**Mackenzie**  
DISTRICT PLAN REVIEW  
TOMORROW'S MACKENZIE  
KA AWATEA HŌU

# **Section 42A Report: Plan Change 23 – Natural Character Natural Features and Landscapes General Rural Zone**

**Report on submissions and further submissions**

**Date: 19 April 2024**

**Figure 1: Tengawai Cliff ONF sought by Hermann Frank (6.12)**

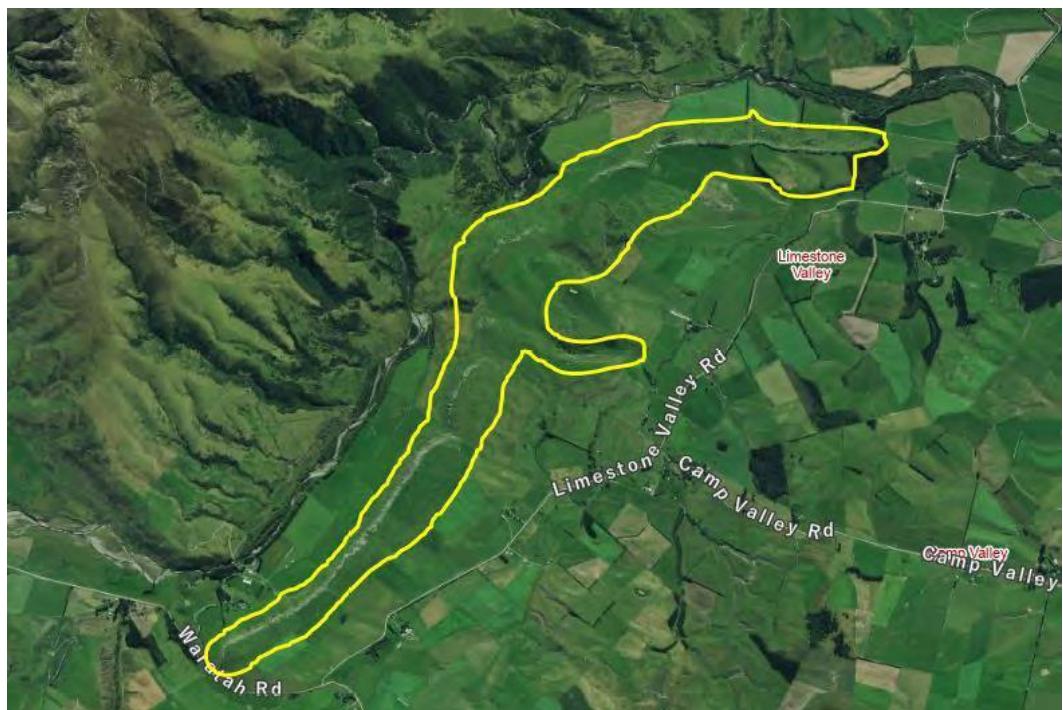
- a) Tengawai Cliffs west of Albury, a limestone scarp of about 6 – 7 km length, which the submitter considers this to be the most outstanding natural feature in the Eastern Mackenzie District (as shown in the yellow ONF outline extent in **Figure 1** below).

**Figure 6: Grampians Station Operative Plan Farm Base Area (Yellow) and amendments to be included in PC23 (in Red)**

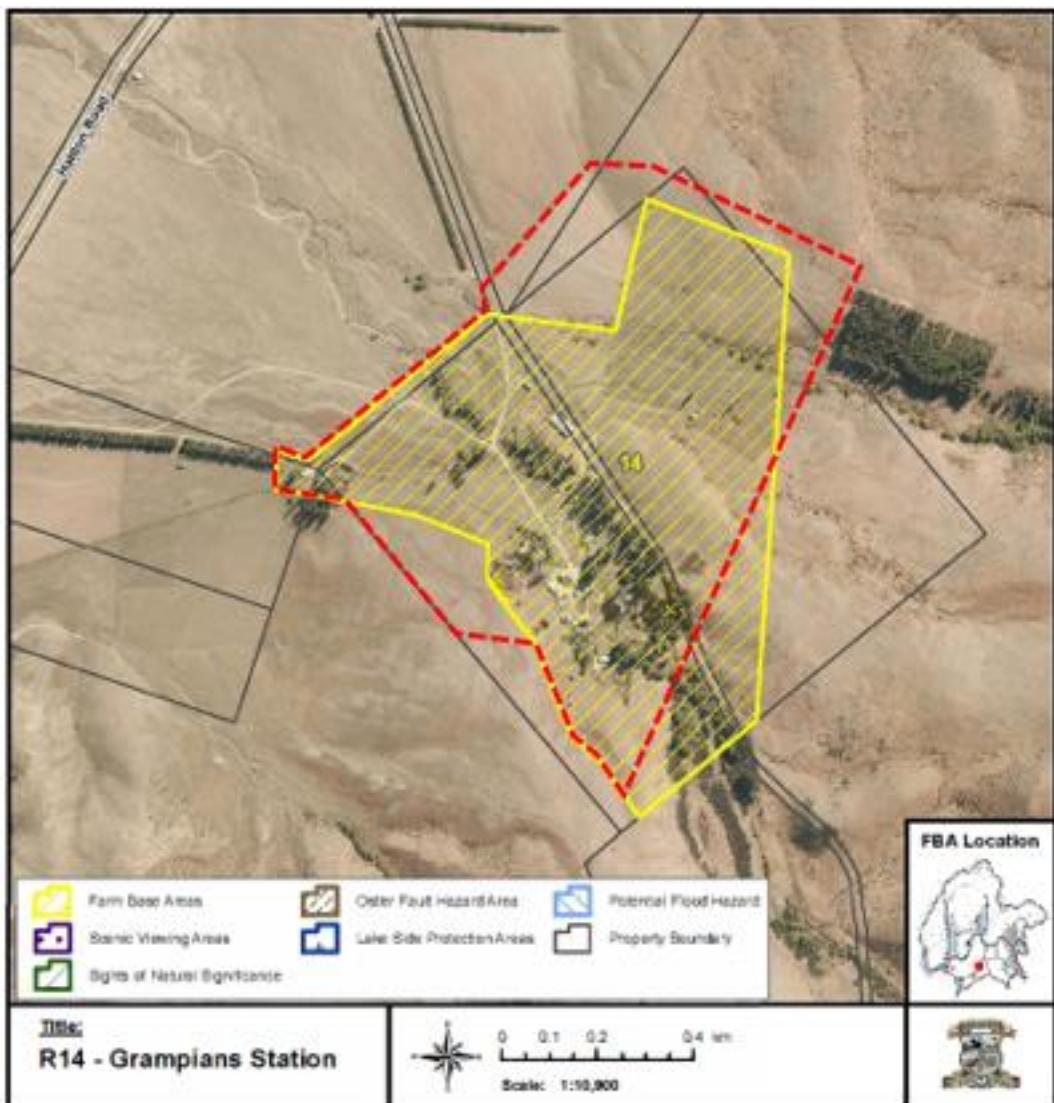
361. In assessing Grampians Station's request to include a further addition beyond the amendment made prior to notification of PC23, I have identified that the Grampians Station FBA boundary included on the EPlan mapping is incorrect. **Figure 6** below shows the nature of the change requested by Grampians Station prior to notification that was included in Appendix 7 to the Section 32 Report; with the red dashed line identifying the area that was to be mapped for inclusion in the EPlan as part of PC23.

**Figure 7: Grampians Station Farm Base Area as notified (in black) and proposed further extension (red shading)**

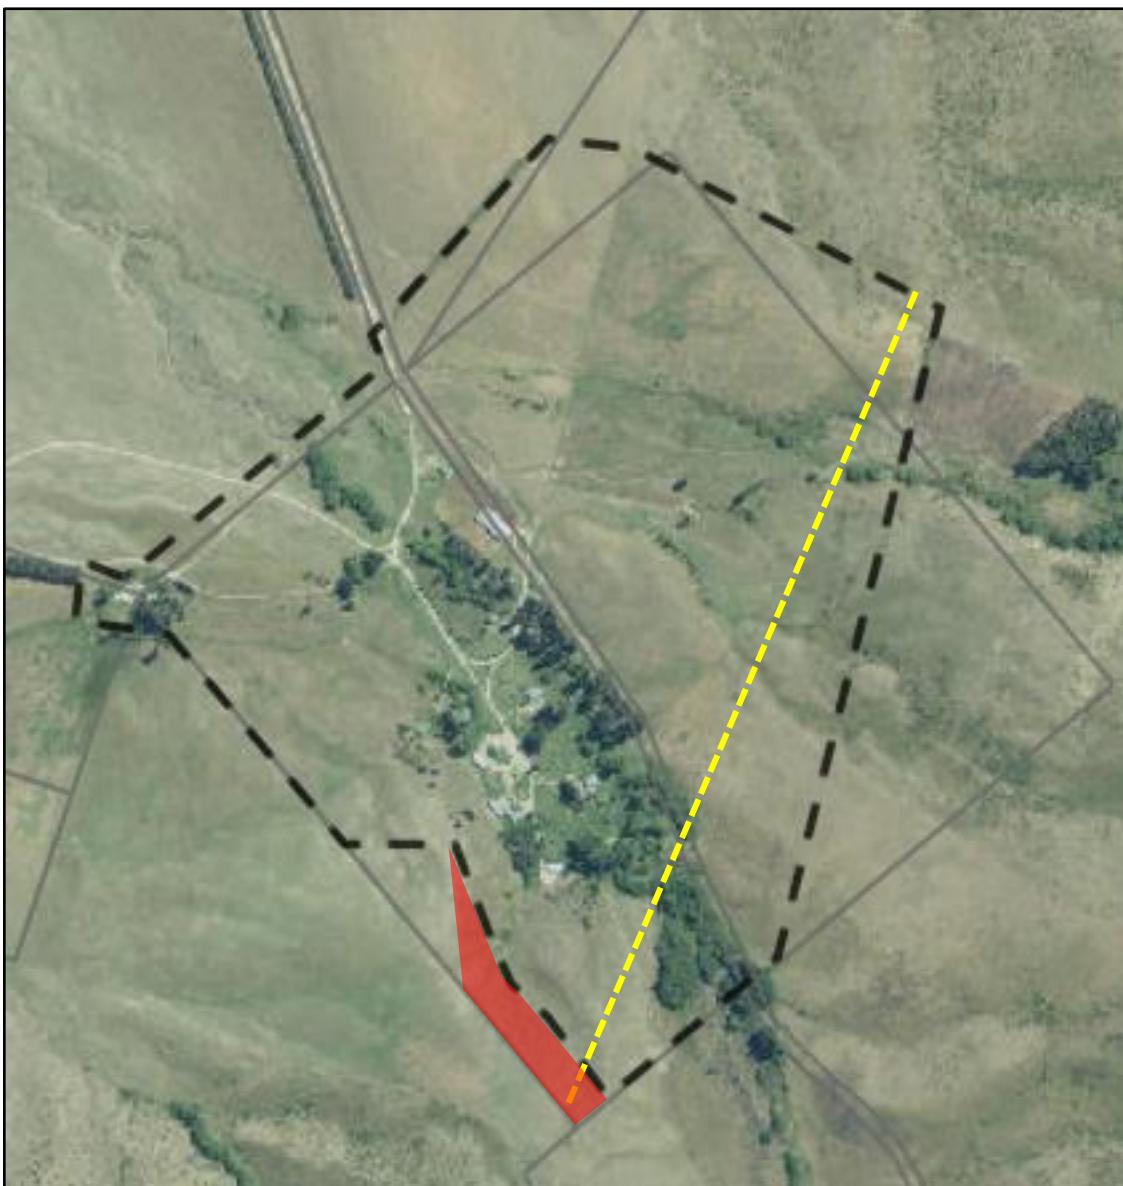
362. An EPlan mapping error has meant that the Grampians Station FBA as notified includes additional land along the eastern boundary beyond that sought by Grampians Station; shown in **Figure 7** below (black outline). Notwithstanding, the mapping of this enlarged FBA is supported by two submissions from Grampians Station (32.01, 52.29).
363. Grampians Station submission (32.01) also seeks that this FBA is further extended to include the additional area shaded in red (as also indicated in **Figure 7**).

364. The information provided to the Council by Grampians Station prior to notification of PC23 was clear that the change sought to the eastern boundary of FBA R14 would follow the existing Transpower Lines (shown as a yellow dashed line in **Figure 7** above). This change was to partly off-set the additional land to the north and southwest sought to be included in the FBA. Overall the intention was that the FBA increase in size from 67.5ha in the Operative Plan to 74.0ha in PC23. The EPlan planning maps currently indicate an FBA being some 87.3ha in size.
